**SCOPE OF SERVICES**  
**FOR MITS INTERIOR FIT UP – QUESTIONS & ANSWERS**  
**SET #3**

"IN-LINE" ITS HANDHOLE (TYP)  
 NOT TO SCALE

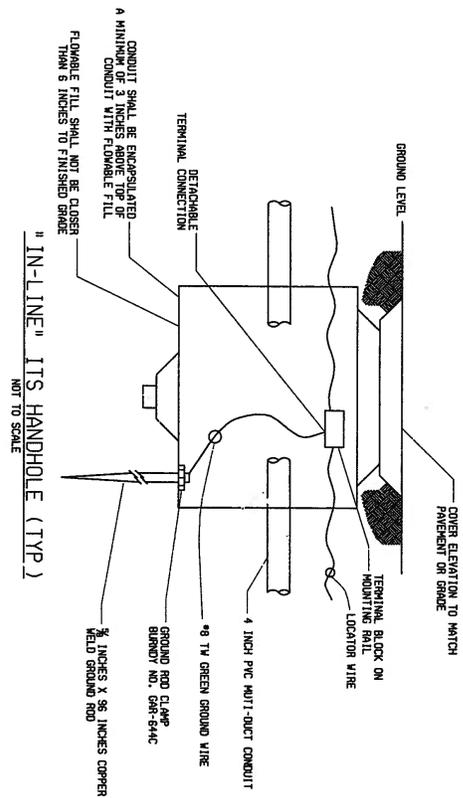
Question 10: Is there a detail for the Manholes indicated to be (type "d") new on drawing 4?

Answer 10: Yes, see attached file showing the Type D handhole.

3 INCH SCHEDULE 90 CONDUIT -  
 MAINTENANCE CONDUITS SHALL PROJECT  
 FROM THE HANDHOLE TO THE METER  
 SHALL PROJECT AT A MINIMUM 2 INCHES AND  
 MAXIMUM 3 INCHES INTO THE HH.

CONDUIT ENTRIES INTO HANDHOLE (TYP)  
 NOT TO SCALE
